City of Mississauga Department Comments

File(s): A114.22 Ward: 3

The applicant requests the Committee to approve a minor variance to allow an existing carport with:

Property Address: 3438 Bannerhill Ave

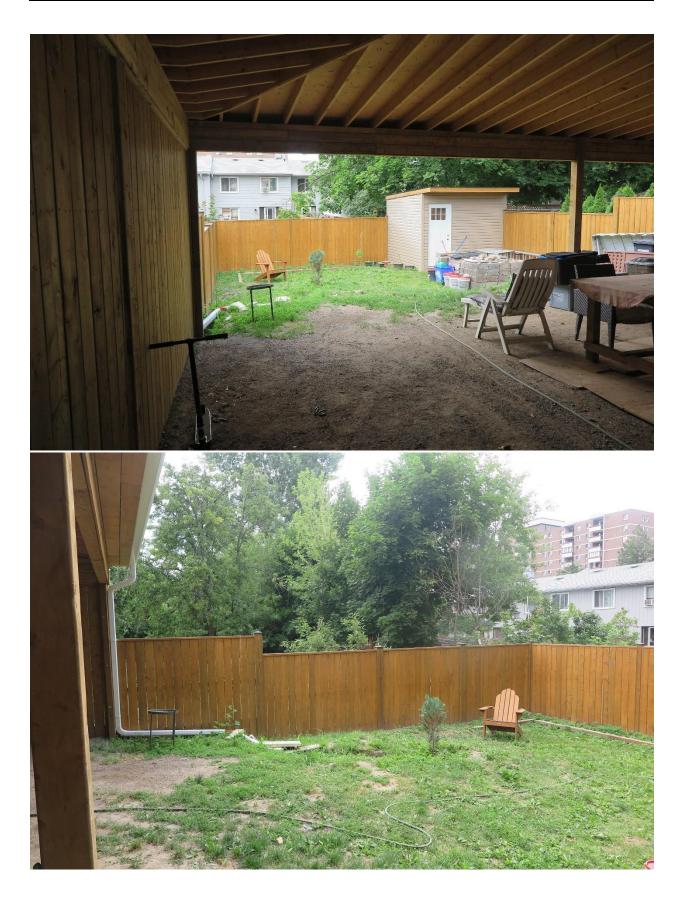
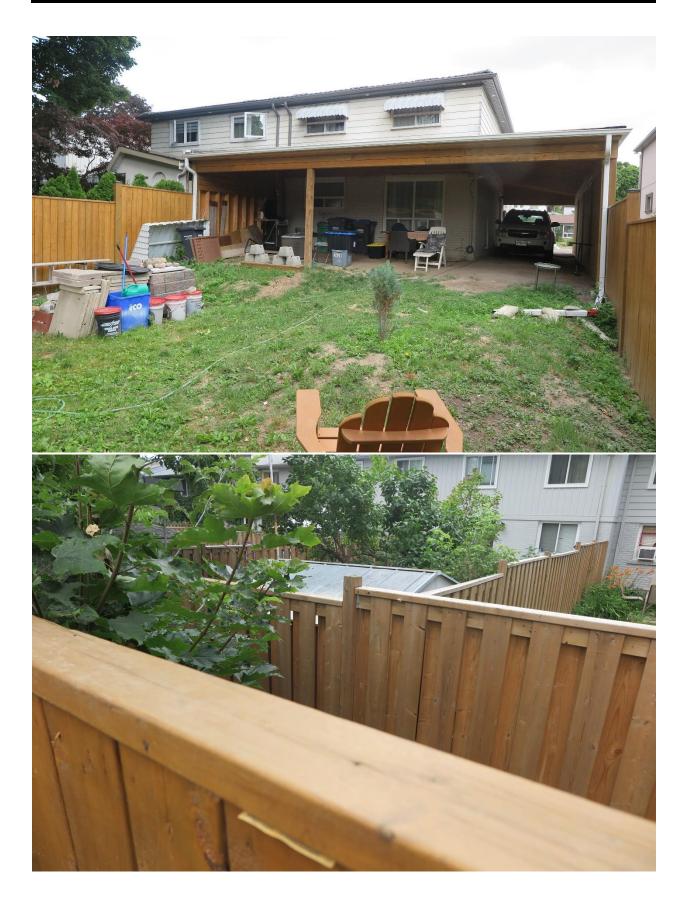
Enclosed are some recent photos of the subject property. In our previous comments we indicated that it was evident that the hard surface area has been significantly increased on this property. We noted that the topography of this lot is such that all the drainage from the carport and rear porch is directed towards the rear yard. We checked the Grading Plan approved for the Forest Glen Subdivision (Road Grades & Lot Elevations Plan C-6824 dated Dec 1963) and noted that for this lot the drainage was designed to be directed to the rear yard and then towards the abutting lot to the east (#3432 Bannerhill Ave.).

According to the Grading Plan reviewed, we also noted that the accessory structure located in the rear yard may also be impeding drainage from the abutting property to the west (3440 Bannerhill Ave.) as drainage from this property was designed to be directed across the subject property and be directed to the east. We are not aware of any drainage related concerns expressed from 3440 Bannerhill Avenue.

On our recent site inspection we also observed and note that abutting the rear fence of the subject and abutting properties there is an open undeveloped area, almost like a laneway or servicing corridor, possibly related to the existing easement (see photos depicting this area). This open undeveloped area also assists in accommodating some of the drainage in the area. In view of the above, and should Committee see merit in the request we have no further comments.
